# UNITED STATES DEPARTMENT OF THE INTERIOR BUREAU OF LAND MANAGEMENT

SUNDRY	INIVINIVISSU25							
Do not use the abandoned we	6. If Indian, Allottee or Tribe Name							
SUBMIT IN	7. If Unit or CA/Agreement, Name and/or No.							
Type of Well	8. Well Name and No. HUGH LAKE 90							
Name of Operator     DUGAN PRODUCTION COR		9. API Well No. 30-045-29829-00-S1						
3a. Address 709 E MURRAY DRIVE FARMINGTON, NM 87499	3b. Phone No. (include area code) Ph: 505.325.1821		10. Field and Pool or Exploratory Area BASIN FRUITLAND COAL

Attachment to notice of Intention to Abandon:

Re: Permanent Abandonment Well: Hugh Lake 90

### Planned P & A Schematic

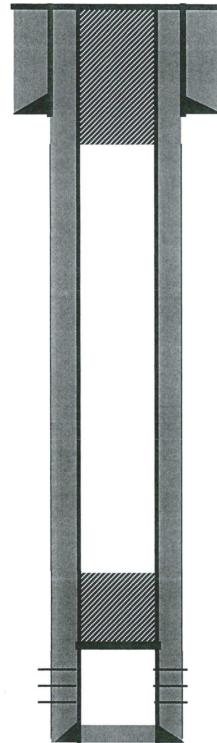
- 1. Plugging operations authorized are subject to the attached "General Requirements for Permanent Abandonment of Wells on Federal and Indian Lease."
- 2. Farmington Office is to be notified at least 24 hours before the plugging operations commence (505) 564-7750.
- 3. The following modifications to your plugging program are to be made:
  - a) Set Plug 2 (336 0) ft. to cover the Kirtland and Ojo Alamo tops. BLM picks top of Kirtland at 286 ft. BLM picks top of Ojo Alamo at 190 ft.

You are also required to place cement excesses per 4.2 and 4.4 of the attached General Requirements.
